RE: New York SMSA Limited Partnership d/b/a Verizon Wireless installation of a public utility personal wireless facility at the property known as 52 Montrose Station Road, Town of Cortlandt, NY

In connection with the Facility, we received comments from the Town's Director of the Department of Technical Services, Michael Preziosi, P.E. ("Town Engineer") on March 11, 2019 and the Town's Consultant, The Center for Municipal Solutions ("Town Consultant"), dated April

Response to the Comments from Town Engineer:

DRAWING NO.:	PAGE NO.:
Z1	1 of 11

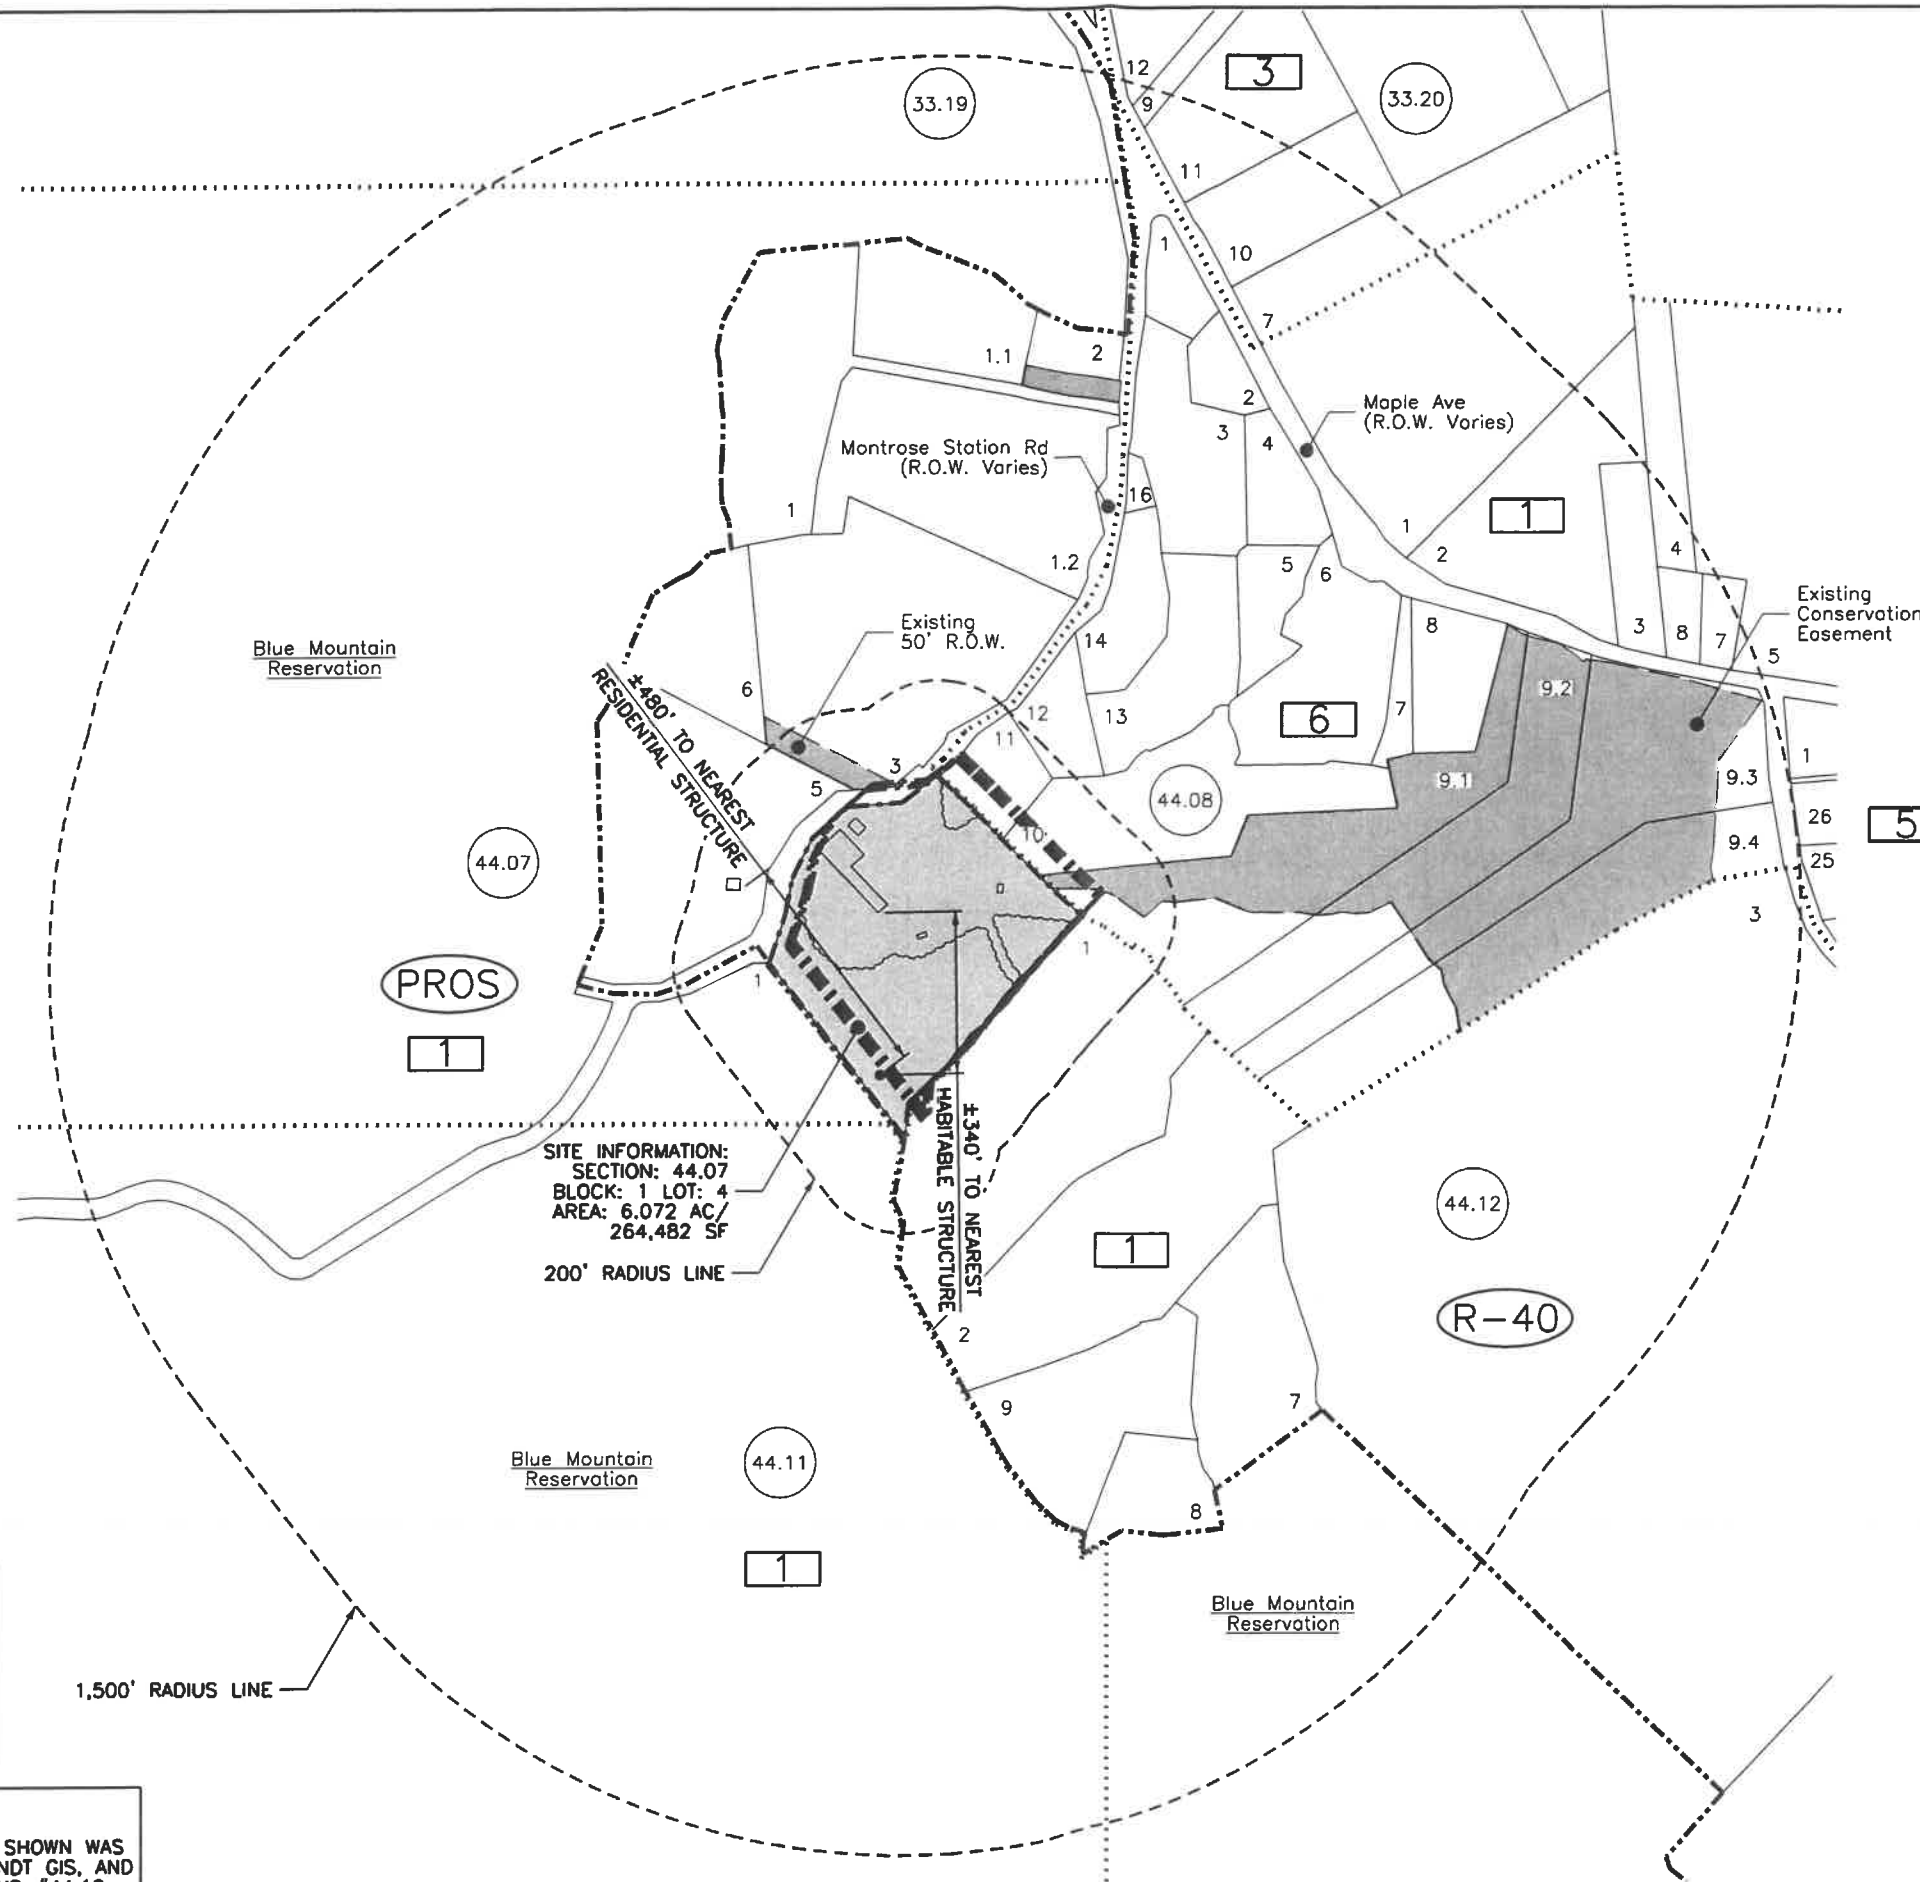
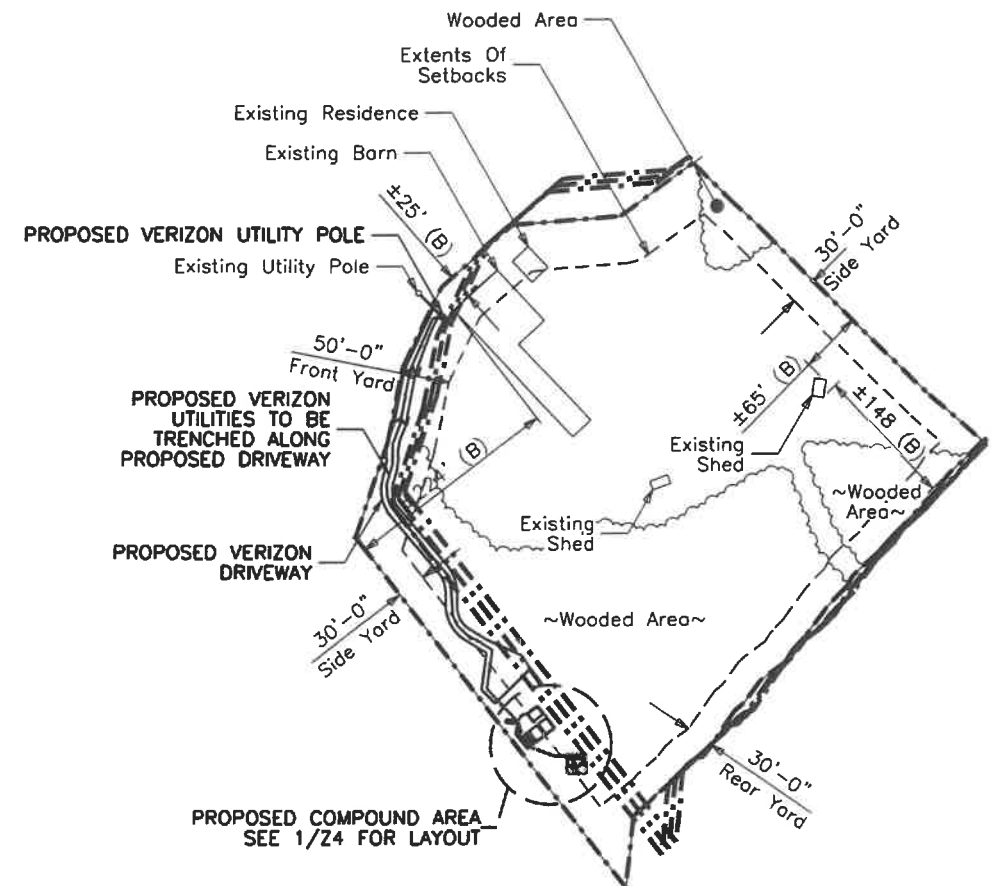
Comment #6: *Section 277-6.J is not acceptable. A long form EAF was completed yet no environmental analysis was completed by the Applicant. The proposed construction of the 140-ft lattice tower and compound will require a tree removal and topographical alteration. In addition total land disturbance may exceed 1acre necessitating a storm water pollution prevention plan in accordance with the SPDES General Permit for Construction Activities and Chapter 262 of Town Code. Other environmental approvals may also be required.*

Response: As noted above, a long EAF form was completed. Moreover, as indicated in note 5 on Page Z1 of the Revised Plans, “total land disturbance is to be below 1 acre,” so no SWPPP is required.

DRAWING NO.: Z3 PAGE NO.: 3 of 11

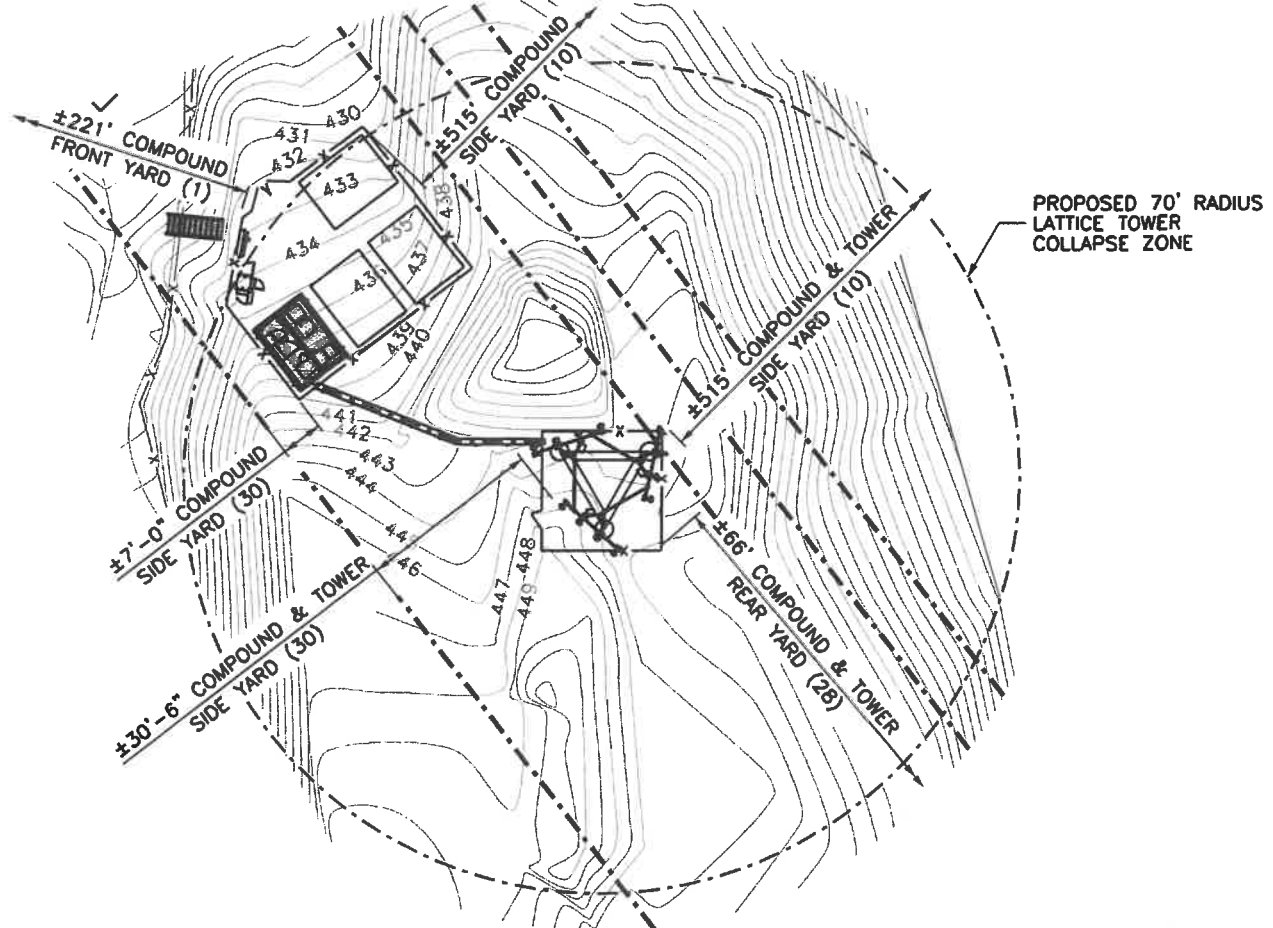
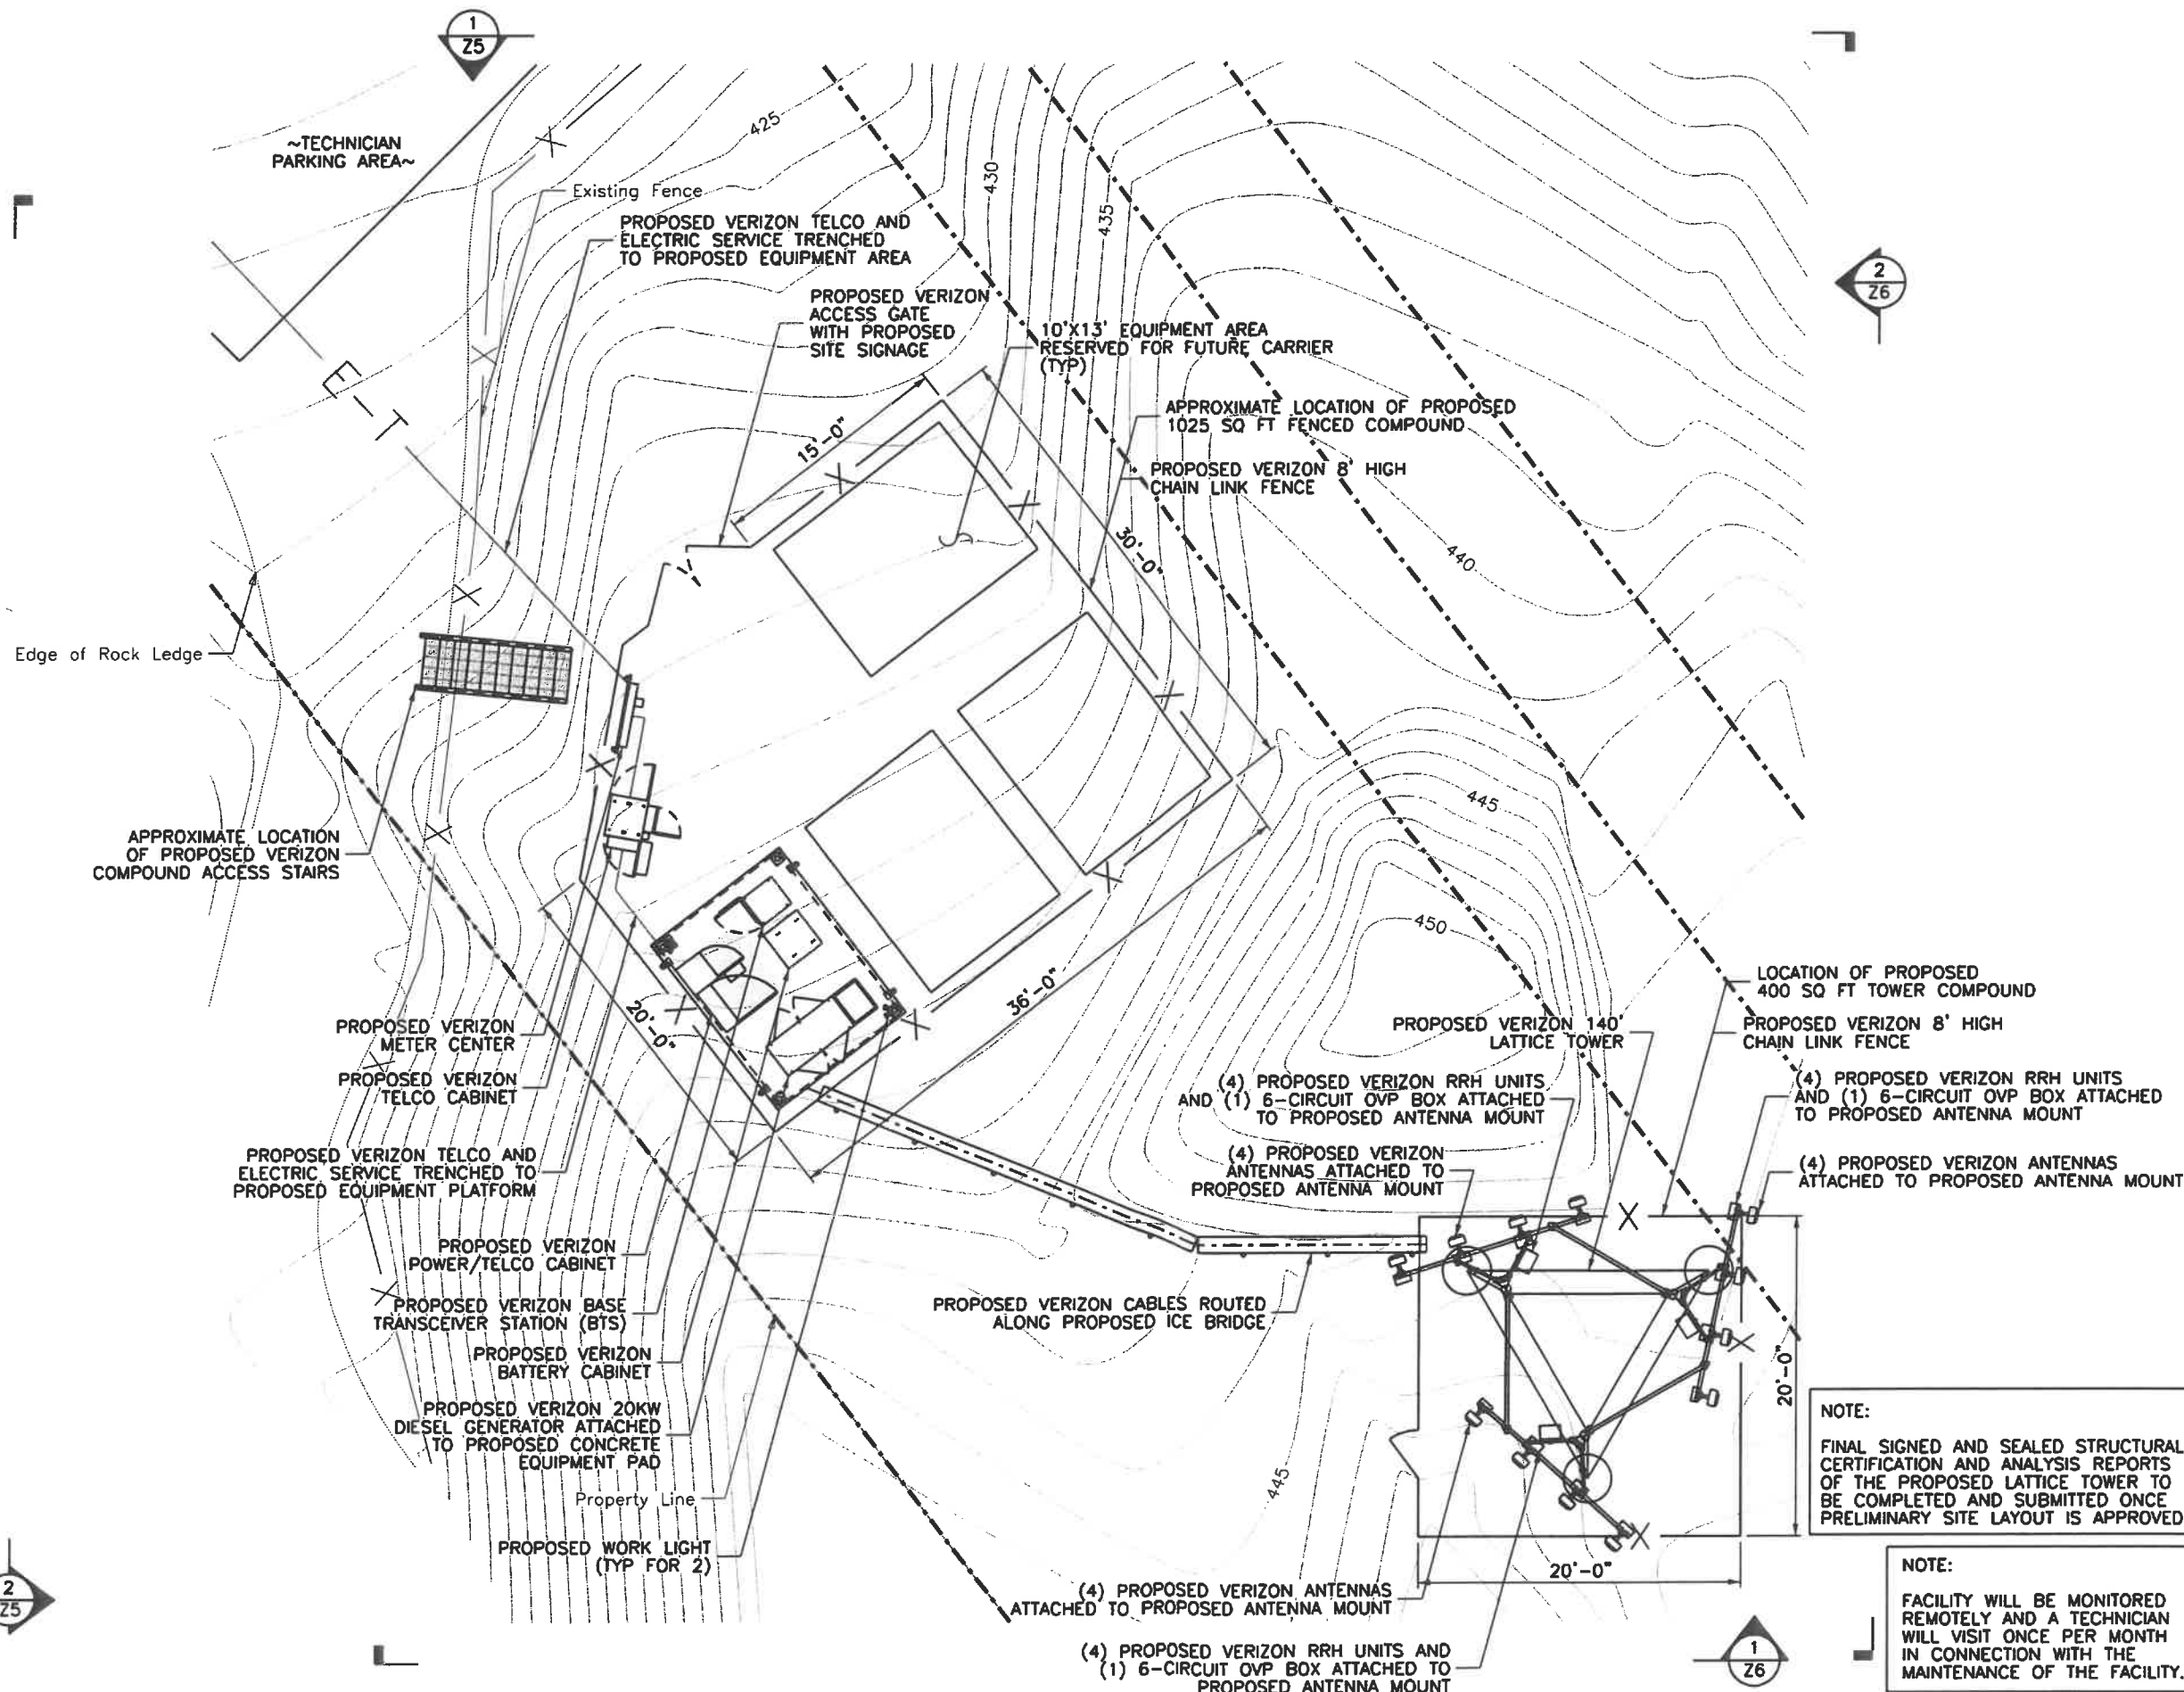
- *Extensive re-grading is proposed. Field based topography within 100-ft of the proposed limits of disturbance shall be provided. In addition the Applicant must provide a topographic and geomorphologic study within the disturbance limits. The Applicant shall complete a Steep Slope analysis in accordance with Town Code Chapter 259.*

- (vi) Pages Z3 and Z10 of the Revised Plans shows field based topography within 100ft. of the proposed limits of disturbance. Additionally, it is respectfully requested that the topographic and geomorphological study within the disturbance limits and a Steep Slope analysis in accordance with Town Code Chapter 259 both be a condition of the building permit, after the location of the Facility has been approved; and
- (vii) Page T1 of the Revised Plans includes a note that the tower owner will maintain the Facility during expected monthly visits and that that the applicant will comply with code requirements regarding abandonment/discontinuance in that unlikely event.
